IEEE P802.3z

Comments and Responses on Clauses 36 and 37 (PCS, PMA, LC) of 802.3z Draft 2

Prepared by:
Rich Taborek, Amdahl
revision date
March 9, 1997

Figure 36-5—Transmit ordered_set state diagram

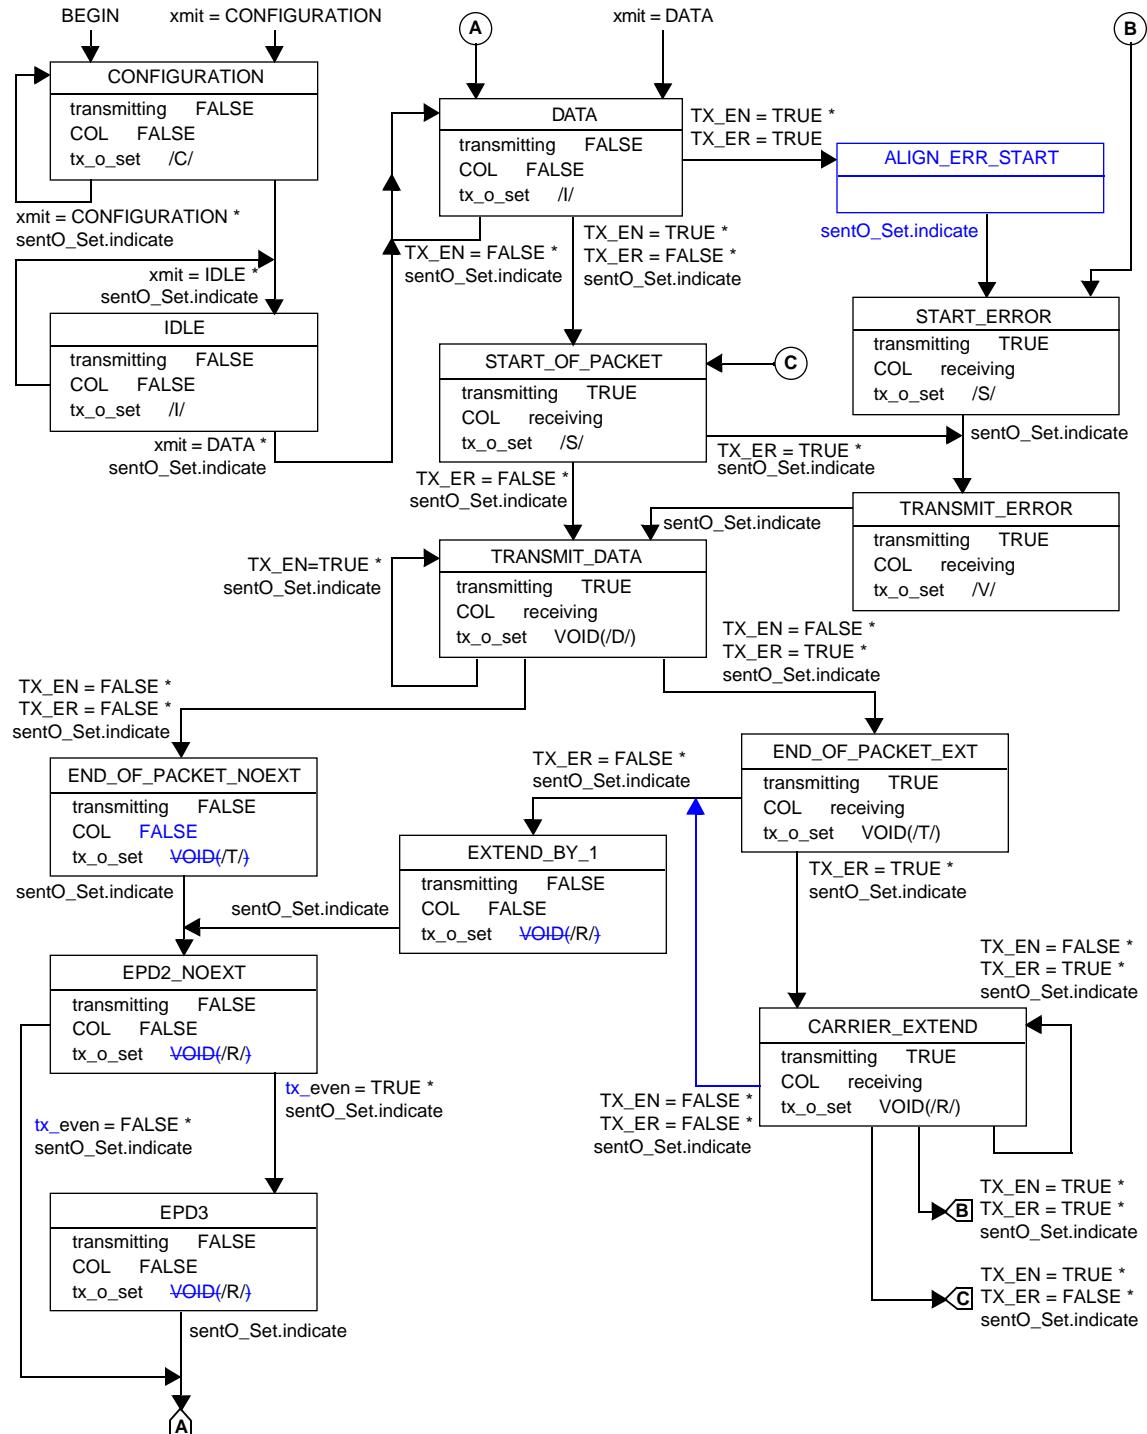
I'm not sure if anyone is working on the transmit process but I have a question. In the DATA state, TX_EN & TX_ER go true for the first byte of preamble then TX_ER goes false for the remainder of the packet. (I don't know why, let's just say it does.) If the first byte of the packet is odd-byte aligned so that sentO_Set.indicate is false for the first byte and true for the second byte when TX_ER is false, the transmit process will proceed to START_OF_PACKET state and the receiving PCS will never know that there was an error with this packet. Is this the desired operation?

On the transition from DATA to START_OF_PACKET, I don't believe you need the even=FALSE condition as sentO_Set.indicate condition covers this.

COL should be assigned the value FALSE in END_OF_PACKET_NOEXT state since transmitting equals FALSE here.

The transition from EPD2_NOEXT state to A should have the condition even=FALSE not even=TRUE.

It seems as though it must be true that you could actually spend 0 time in state ALIGN_ERR_START. Do we want to show it this way? The transition from DATA to ALIGN_ERR_START is the only transition without sentO_Set.indicate. I hope this doesn't result in confusion for people. I'll suggest a more clear set of transitions would have TX_EN=TRUE * TX_ER=TRUE * sentO_Set.indicate going to ALIGN_ERR_START state and TX_EN=TRUE * TX_ER=TRUE * sentO_Set.indicate going to START_ERROR state.

When this machine is in the CARRIER_EXTEND state and TX_EN=FALSE * TX_ER=FALSE * sentO_Set.indicate, shouldn't the transition take you to EXTEND_BY_1? The way this looks, packets with 0, 1 or 2 Carrier Extends from the MAC will look identical to the PMA. The following table should describe what the Ends should look like for a given packet ending from a MAC:

It looks like the Transmit state machine makes some fragments into packets.

I think it would work better if EXTEND_BY_1 was entered on the condition that a preamble byte was consumed. That is the only condition that would create the 3 ending R's case after tx_er and tx_en go low. After tx_er and tx_en go low, you want to add one or two R's depending on alignment, unless a preamble byte was consumed in which case you want to add two or three R's. This is because PCS needs to preserve the length of the carrier event which the MAC signalled.

Response: Accepted. Added a new state, "ALIGN_ERR_START" upon exit from the "DATA" state when "TX_EN=TRUE * TX_ER=TRUE". This state transitions to the "START_ERROR" state upon "sentO_Set.indicate".

Response: Accepted.

Response: Accepted.

Response: Accepted.

Figure 36-6—Transmit code_group state diagram

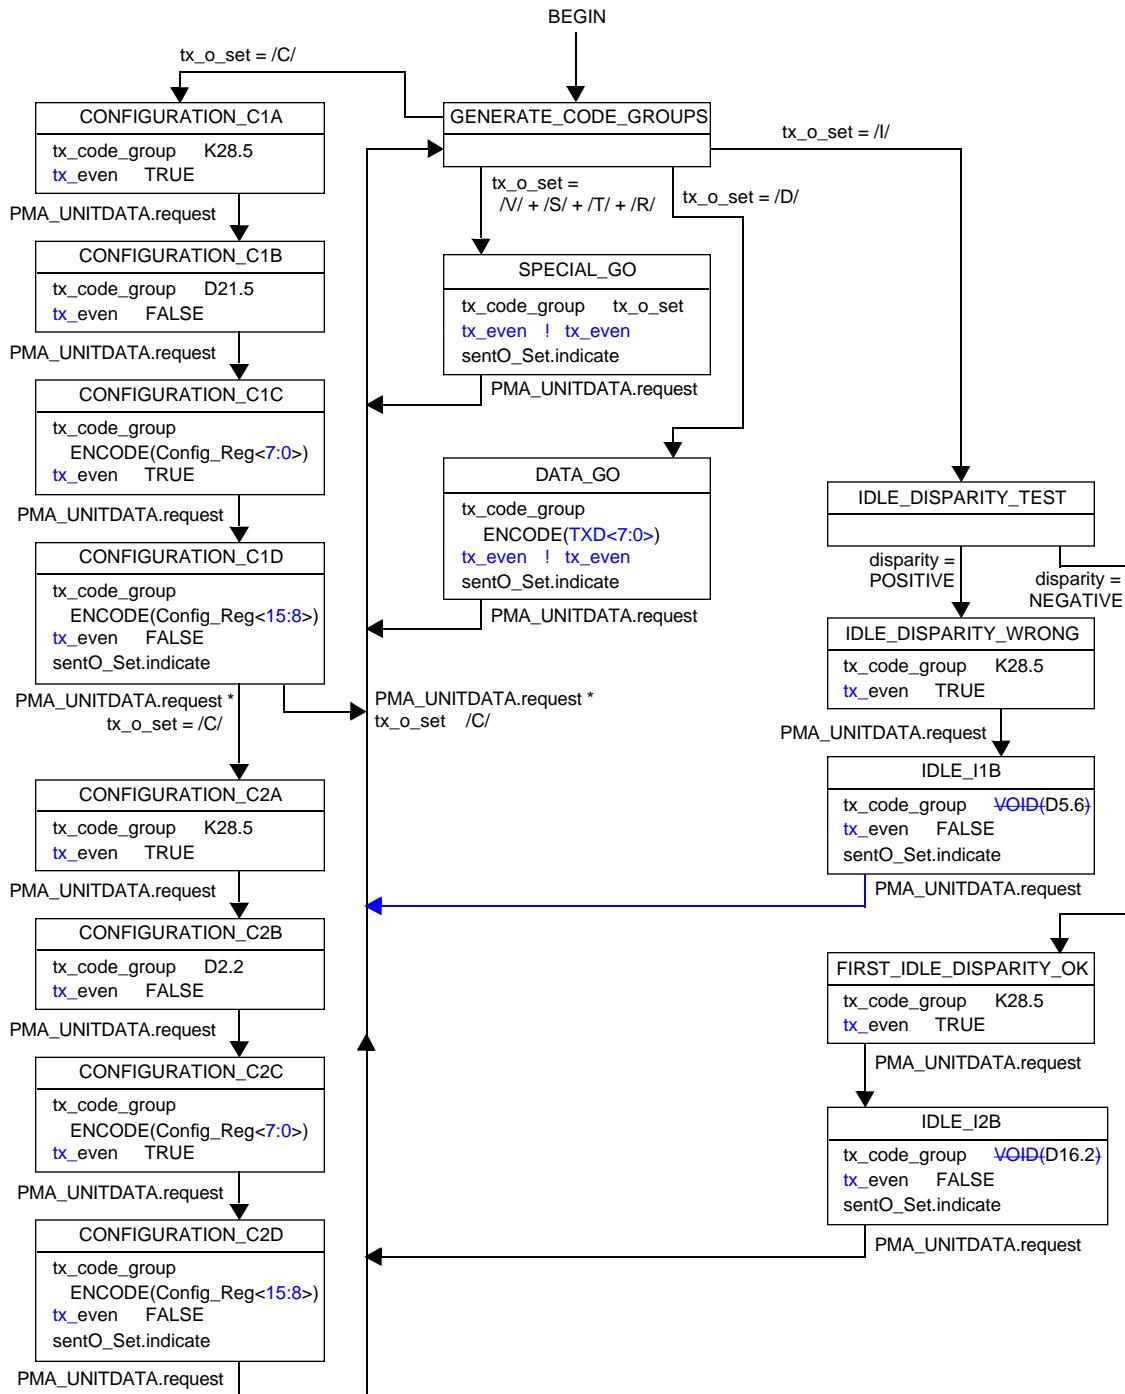
Remove ALIGNMENT_TEST and ALIGN_IDLE_TO_EVEN states since EPD3 sets tx_o_set to /R/ always.

This is a question. In the Transmit code_group state diagram there is some states for Link configuration as we knew it prior to the San Diego meeting. Who has the action item to update this for “Auto-Fibre Negotiation”?

Reverse the bit ordering of “Config_Reg” bits used in the ENCODE function. Also define “Config_Reg” as a parameter of the ENCODE function.

Correct the ENCODE parameter in the DATA_GO state to be “TXD<7:0>”.

Add the term “tx_even <= ! tx_even” to states DATA_GO and SPECIAL_GO to provide proper generation of the tx_even flag in all Transmit code_group states.

Response: Accepted.

Response: Accepted. AFN should use all PCS TX and RS state machines.

Response: Accepted.

Response: Accepted.

Response: Accepted.

Figure 36-7—PCS Receive state diagram

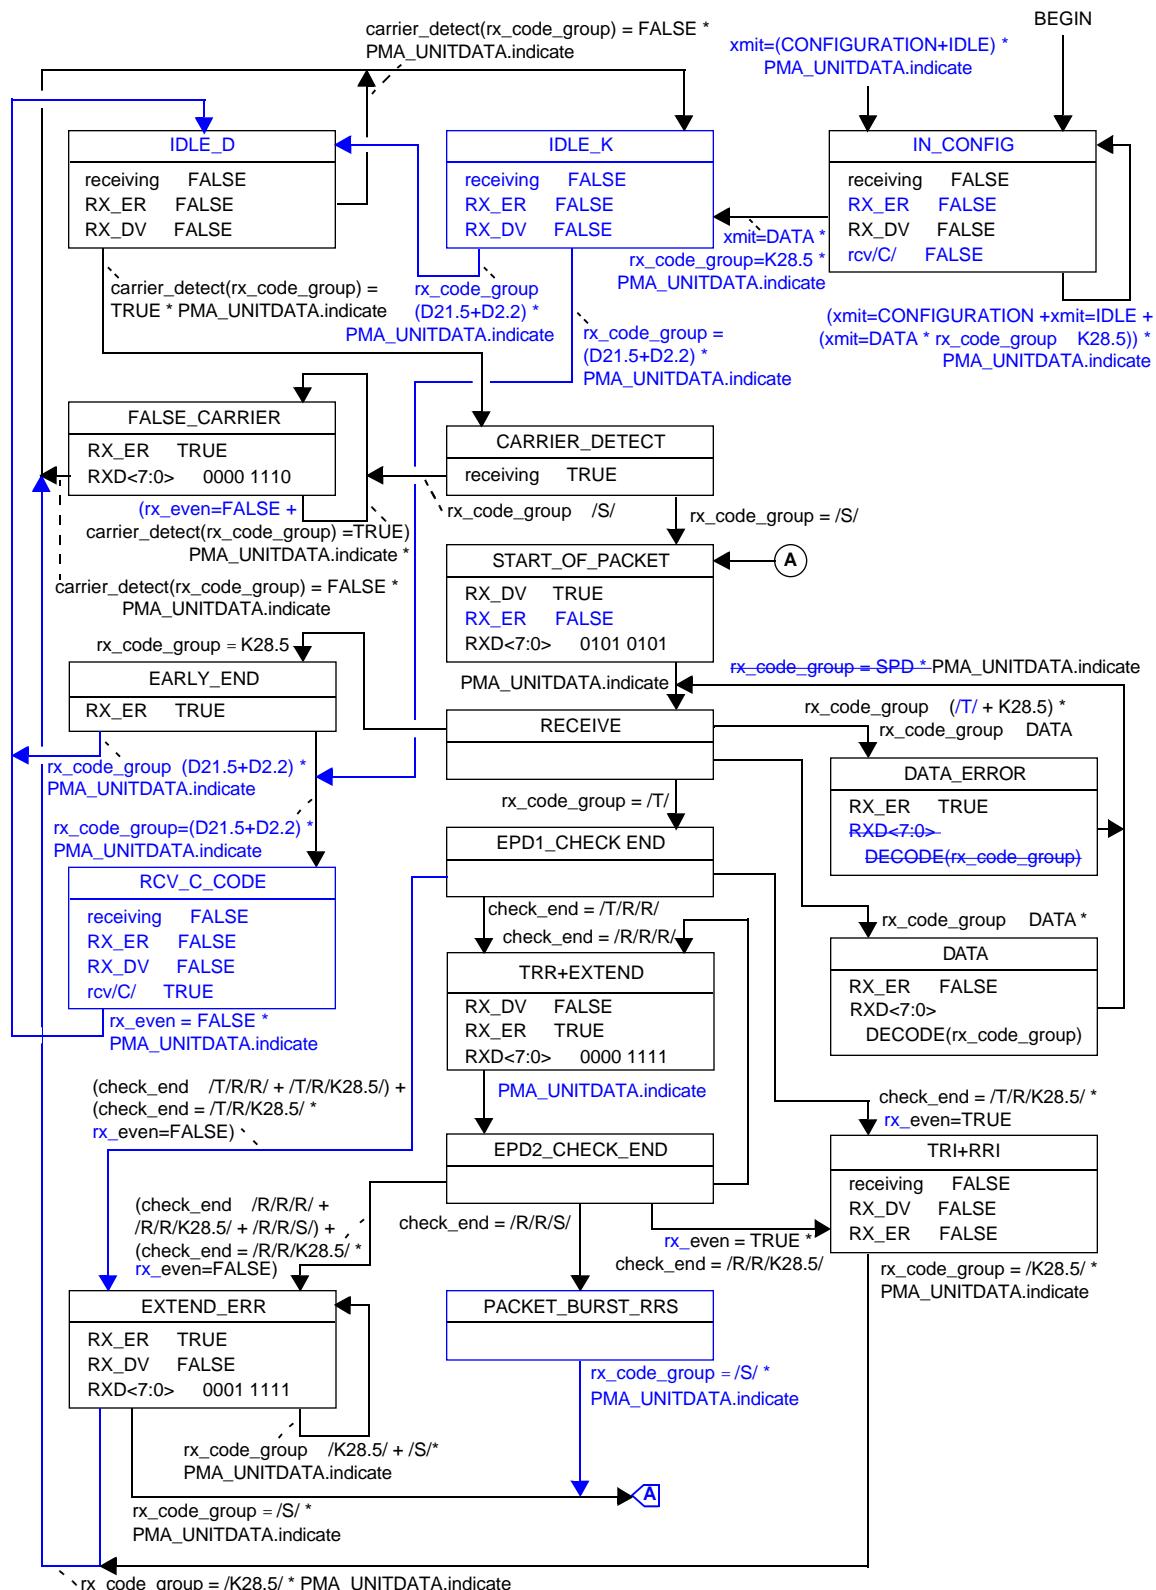
The UCT from EARLY_END and EPD_ERROR should actually be PMA_UNITDATA.indicate.

In the DATA_ERROR state, the assignment of RXD<7:0> should be undefined including not specifying the requirement to use the DECODE(rx_code_group) function. The only parameter that need be specified in the DATA_ERROR state is RX_ER=TRUE.

The way the EXT_ERR is right now is that once we had any error during EXT time, until an /I/ arrives we will stay there. I do not see a problem with it, but I guess it should be written in the text as well, and we should agree on it. One change should be that an /S/ will take us out, otherwise we will throw the full burst on one error in the extend!

The states `EARLY_END` and `EPD_ERROR` go back to `IDLE` immediately while state `EXTEND_ERR` stays there until it sees an `/I/` or `/C/` or `/S/`. Are we being inconsistent, especially between `EPD_ERROR` and `EXTEND_ERR`?

There is a transition from `EPD1_CHECK_END` to `EXTEND_ERR` on the condition that `(check_end /R/R/R/ + /R/R/K28.5/ + /R/R/S/ + (check_end = /R/R/K28.5/ * even = FALSE))`.

If you have TRRI as an EPD you will drop into the “TRR + EXTEND” state on receipt of a “T” and detection of the “TRR” code_groups (via the “check_end” function). At this point RX_ER goes TRUE immediately (RX_DV=FALSE and RXD=0x0F).

This appears to be an error. One way to correct this RX_ER “error pulse” would be to expand the “check_end” function to observe 4 octets for the TRRI condition prior to asserting RX_ER... latency issues???

There's and extraneous “rx_code_group = SPD” in the transition condition “rx_code_group = SPD * PMA_UNITDATA.indicate” from the “DATA” and “DATA_ERROR” states to the “RECEIVE” block.

Delete the term “rx_code_group = /R/” from the exit test in states TRR+EXTEND and PACKET_BURST_RRS.

Add the term “rcv/C/ <= FALSE” to state CONFIGURATION to indicate to the Link Configuration state machine that the PCS Receive state machine is receiving /C/.

Add the state C_CODE containing the same parameters as the state CONFIGURATION so FALSE CARRIER is not reported to the MAC when this situation occurs. This state is also used to set rcv/C/. Enter C_CODE from EARLY_END and IDLE upon detection of the first two code groups of /C/.

Rename the state IDLE to IDLE_K. Add the state IDLE_D containing the same parameters as the state IDLE_K. Enter IDLE_K from IDLE_D and EARLY_END upon detection of an ordered_set which is not /C/ (e.g. /I/), and from C_CODE on an odd_numbered code_group. Enter IDLE_D from IDLE_K and FALSE_CARRIER when carrier is not detected and from states TRI+RRI and EXTEND_ERR when K28.5 is detected.

Delete the state PACKET_BURST_RS. Delete the terms “RX_ER <= TRUE” and “RXD<7:0> <= 0000 1111” from state the term PACKET_BURST_RRS. The exit from PACKET_BURST_RRS should go to the START_OF_PACKET state.

The test to enter CONFIGURATION should be changed to “xmit=(CONFIGURATION+IDLE) * PMA_UNITDATA.indicate”. The test to stay in state CONFIGURATION should be changed to “rx_code_group K28.5 * xmit=(CONFIGURATION+IDLE+DATA) * PMA_UNITDATA.indicate”. The test to exit state CONFIGURATION to IDLE_D should be changed to xmit=DATA * rx_code_group K28.5 * PMA_UNITDATA.indicate”.

Swap the state names of IDLE_K and IDLE_D so that a K character takes you to IDLE_K instead of from IDLE_K, similar to other state transitions.

Rename the state CONFIGURATION to IN_CONFIG and the state C_CODE to RCV_C_CODE as the former are aliases of each other and do not accurately convey the reason the state was entered.

Delete the setting of RXD in states IDLE_D, IDLE_K, IN_CONFIG, and RCV_C_CODE since its value has no meaning when RX_DV=FALSE and RX_ER=FALSE.

Corrected the loop condition for state IN_CONFIG to “(xmit=CONFIGURATION+ xmit=IDLE + (xmit=DATA * rx_code_group K28.5)) * PMA_UNITDATA.indicate”.

Since the state PACKET_BURST_RS was deleted, the term RX_ER=FALSE must be added to the START_OF_PACKET state.

Change all “even” variables to “rx_even”.

Add the term “rx_code_group = /S/” to the exit of state PACKET_BURST_RRS.

The variable RX_ER should be set to FALSE in states IN_CONFIG, and RCV_C_CODE since it is not necessary to communicate the reception or transmission of /C/ to the MAC.

Response: Accepted. The "EPD_ERROR" state has subsequently been subsumed into the "EXTEND_ERR" state which already had a "PMA_UNITDATA.indicate" include in all outputs.

Response: Accepted. Added the term “`RX_DV = FALSE`” to state `EXTEND_ERR`.

Response: Accepted. State “`EPD_ERROR`” deleted and the leftmost output of block “`EPD1_CHECK_END`” now goes to “`EXTEND_ERR`”.

Response: No Change. The latest Receive state diagram (txrxsmd2_plus on the editors site) has `EPD1_CHECK_END` going to `EXTEND_ERR` on the condition `(check_end /T/R/R/ + /T/R/K28.5/ + (check_end = /T/R/K28.5/ * even=FALSE))`. This will check for `/T/` junk/junk/. I don't believe we need the old `EPD_ERROR` state.

Response: No change. Your interpretation of the PCS Receive state diagram is correct. For the /T/R/R/I/ case, the PCS will reflect one octet of carrier extension to the receiving MAC. This is regardless of whether the transmitting MAC requested one octet or carrier extension or the transmitting PCS added one extra /R/ for alignment purposes. The receiving PCS cannot distinguish these two cases and it's my understanding that the receiving MAC also need not distinguish these two cases.

Figure 36-9—Synchronization state diagram

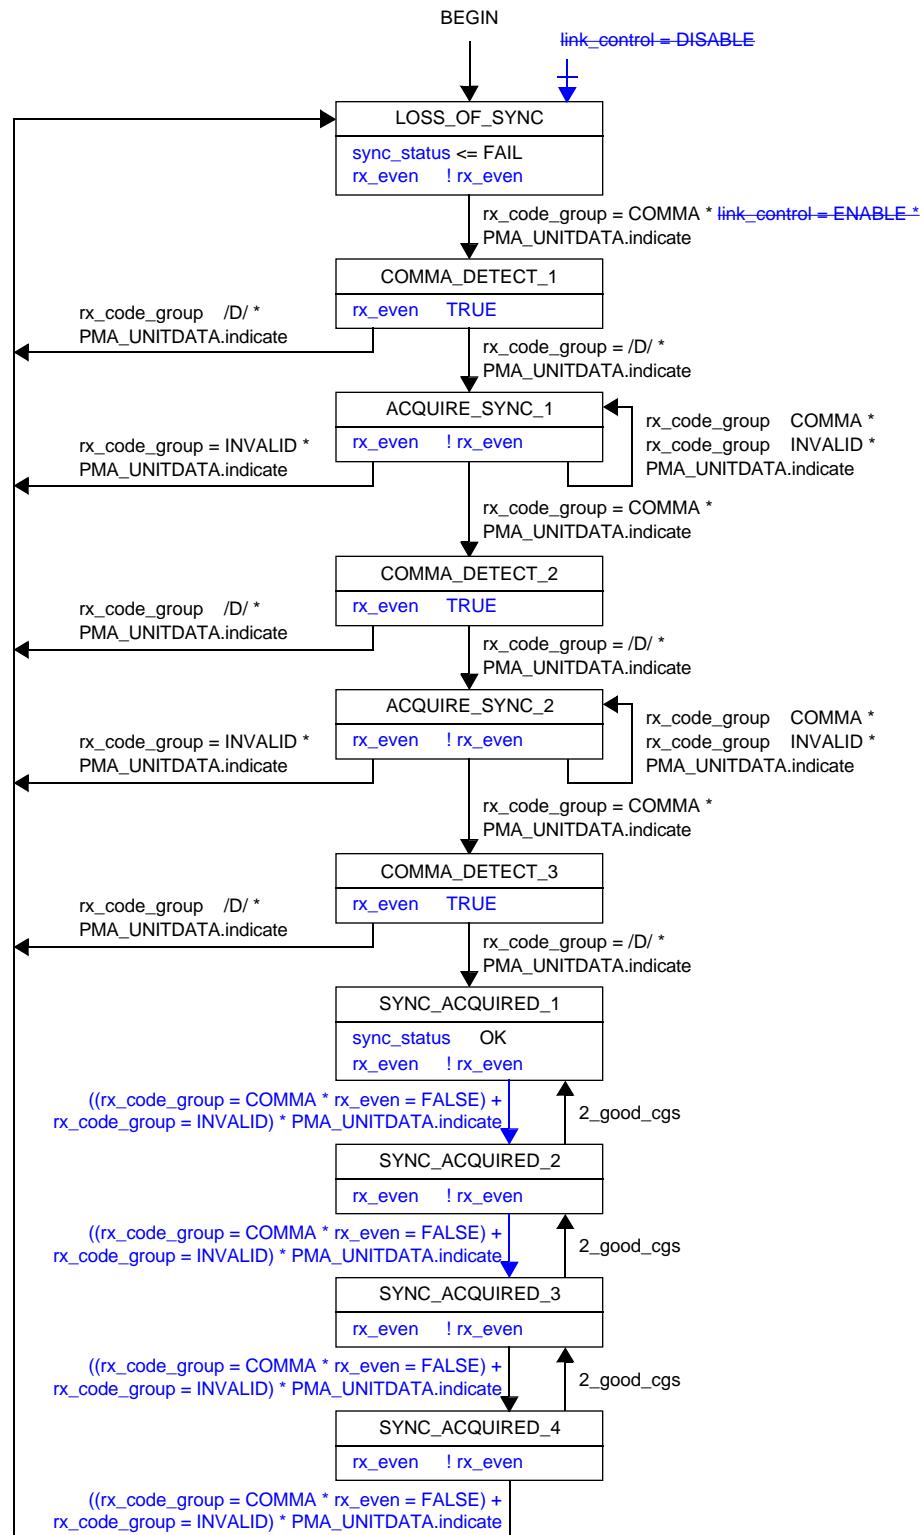
Add the term “rx_even <= TRUE” to states COMMA_DETECT_1, COMMA_DETECT_2 and COMMA_DETECT_3. Add the term “rx_even <= ! rx_even” to states LOSS_OF_SYNC, ACQUIRE_SYNC_1, ACQUIRE_SYNC_2, SYNC_ACQUIRED_1, SYNC_ACQUIRED_2, SYNC_ACQUIRED_3 and SYNC_ACQUIRED_4.

The term “link_status <= OK” should be deleted from states SYNC_ACQUIRED_2, SYNC_ACQUIRED_3 and SYNC_ACQUIRED_4.

If an alignment error occurs, and we don't lose sync, all the SYNC_ACQUIRED_X states only toggle rx_even. It seems that they need to correct rx_even in this case or flag an error.

Response: Accepted. Fixed by treating a misaligned comma in all SYNC_ACQUIRED_X states as an error similar to rx_code_group = INVALID. Also redefined the 2_good_cgs function to treat a misaligned comma as an error.
